September 19, 2006 CPC

STAFF'S  
REQUEST ANALYSIS  
AND  
RECOMMENDATION

07PR0140

Lynchester Properties  
(Franklin Street Marketing)

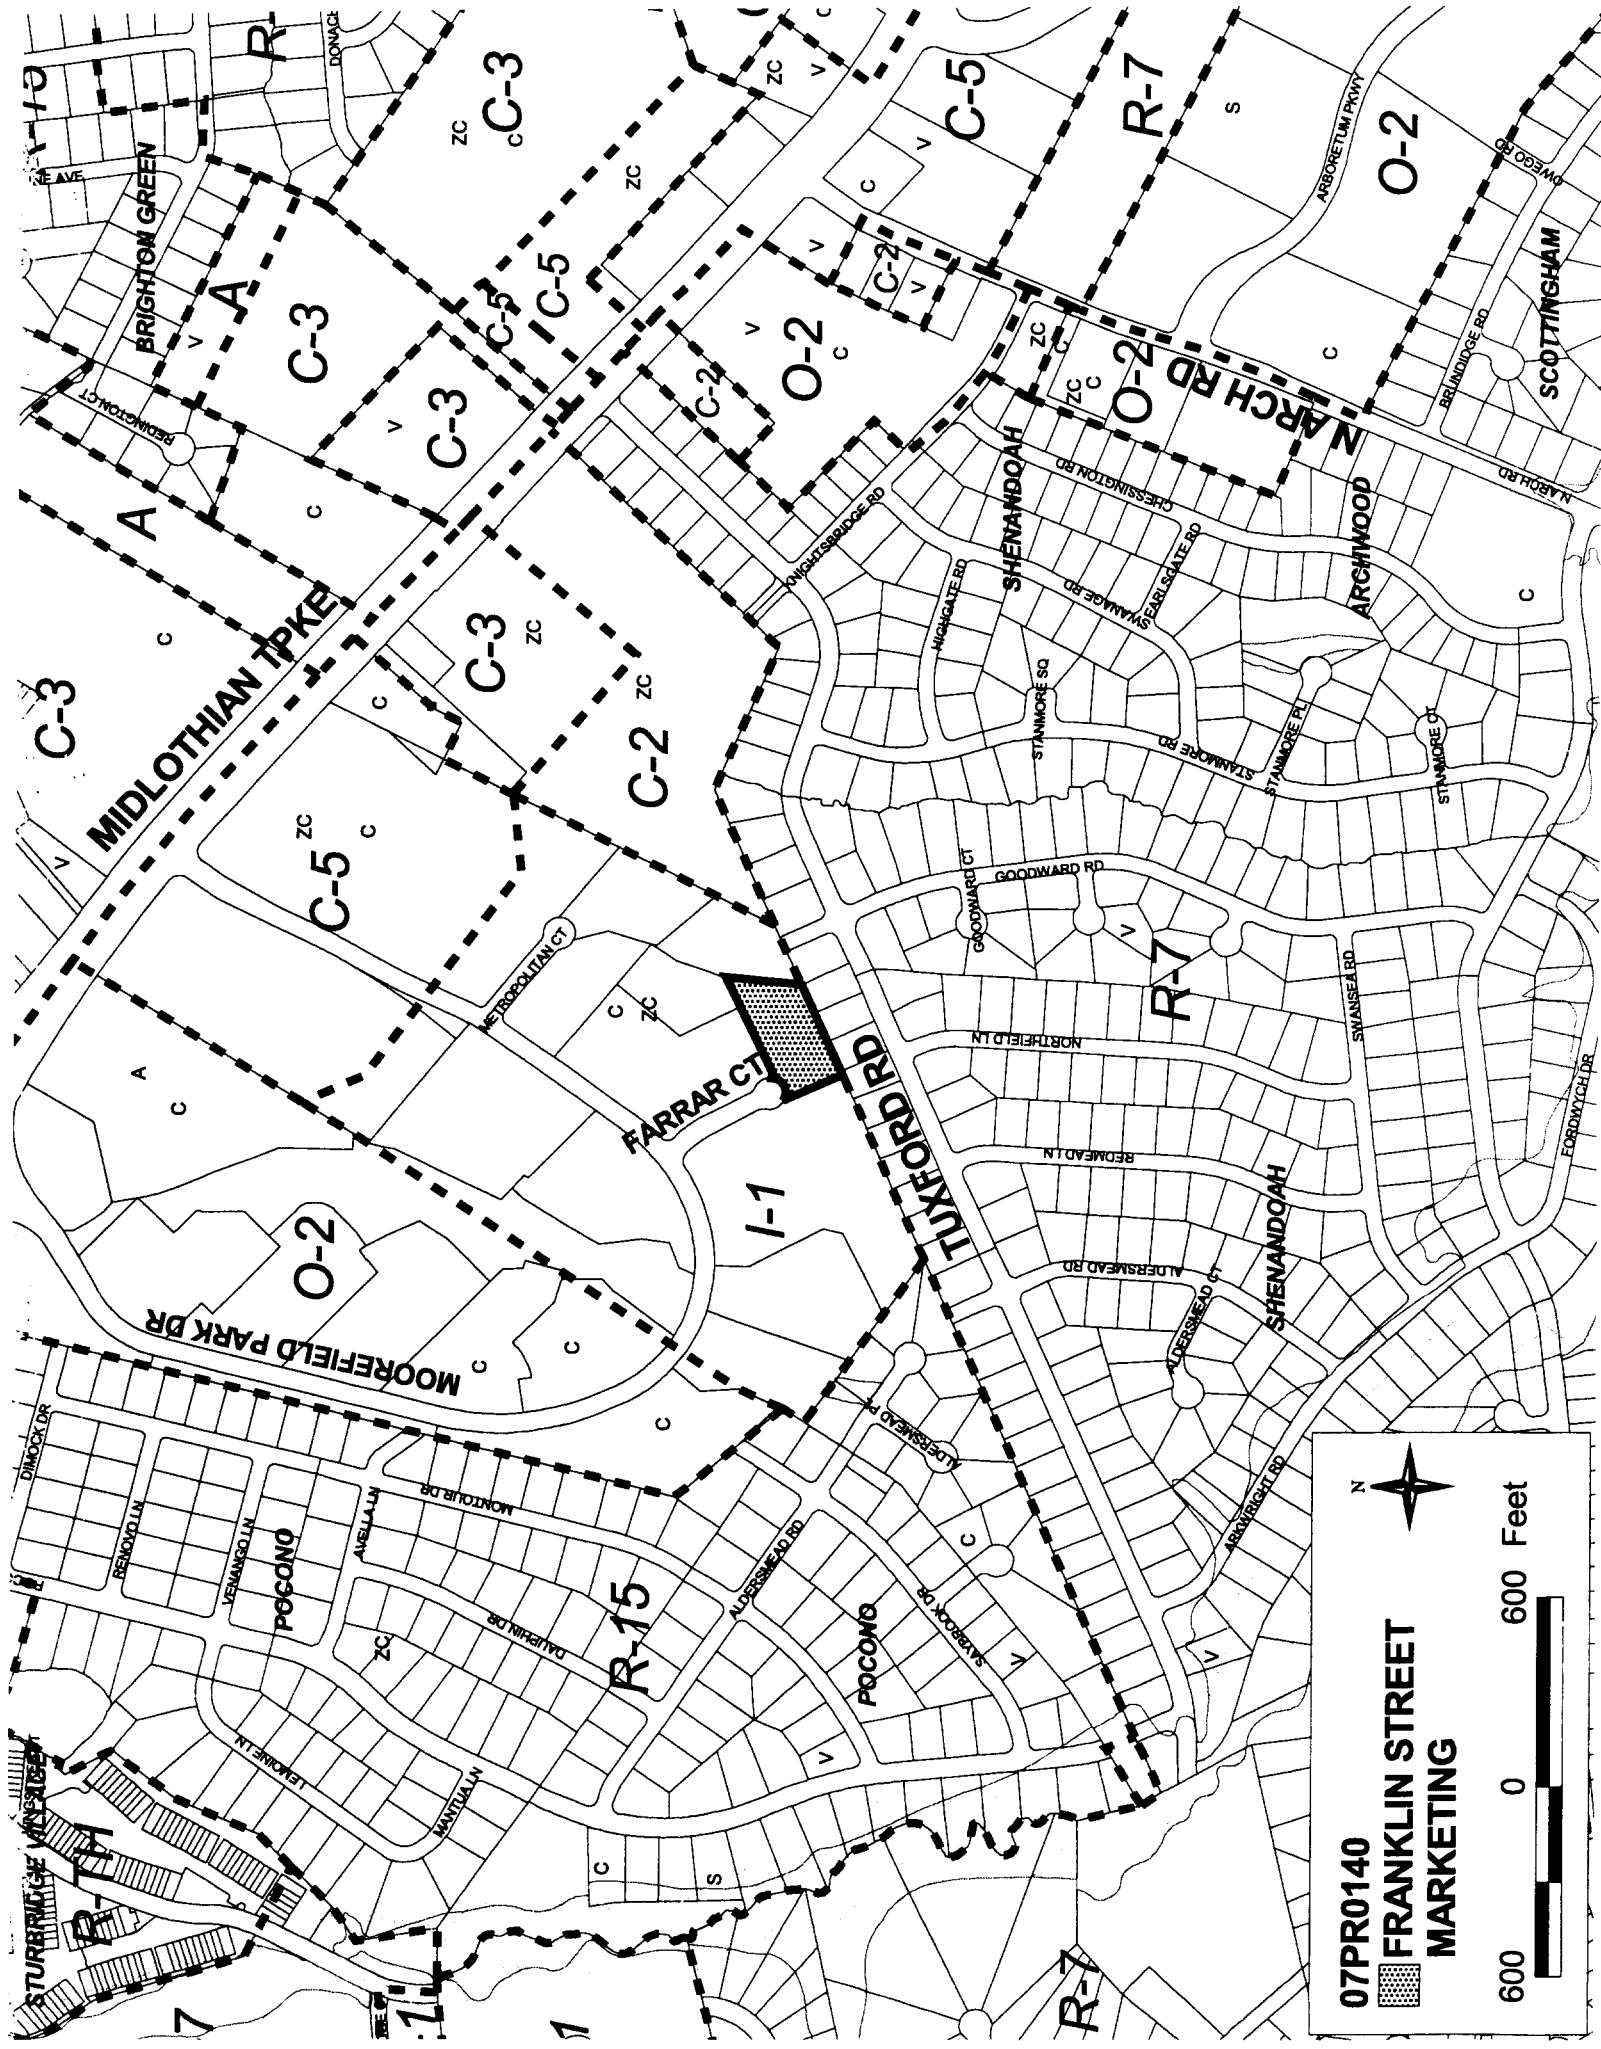
Painted concrete block noted on the plan will be replaced with split faced block, color to blend with proposed masonry materials.

The site must be irrigated according to the Moorefield Design Guidelines and Criteria (MDGC).

Site lighting, luminaire housing and light poles, shall be flat black or a color to match the color of the metal proposed for the building.

The combination of clear glass and tinted glass is approved as proposed with the understanding that window treatments will comply with the MDGC and any variances must first be approved by MARC.

MARC has not yet received a sample of the proposed granulated surface membrane roof material. However we will support the County's decision on the granulated surface membrane roof and its color.

# FSM Minimum County Req. Landscape Plan

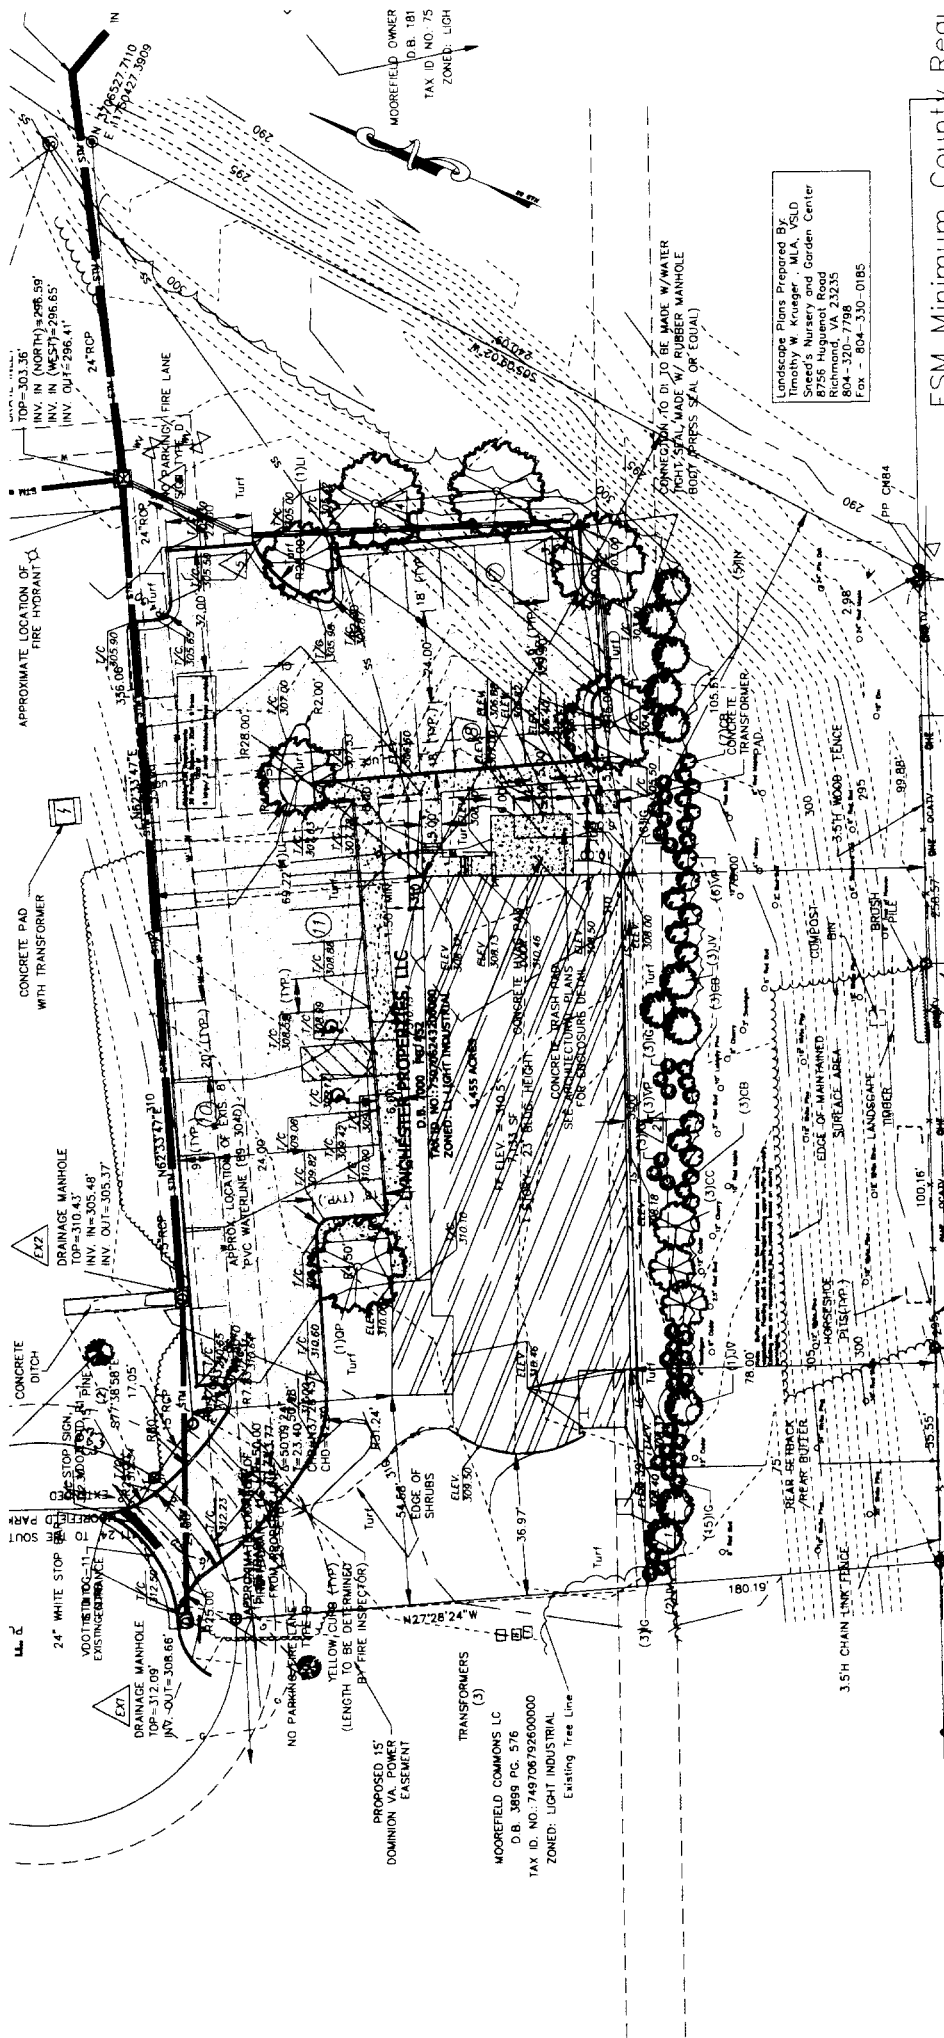
- 1. Add a note to the landscape plan stating "Upon completion of grading an inspection of the buffer landscape will be made in order to determine if additional landscape is required to meet the landscape density requirements of perimeter landscape "C" times two (2)" (P)
- 2. Provide perimeter landscape "J" along the cul-de-sac. (P)

3. Revise the landscape plan to provide the required number of trees within the parking area. (P)
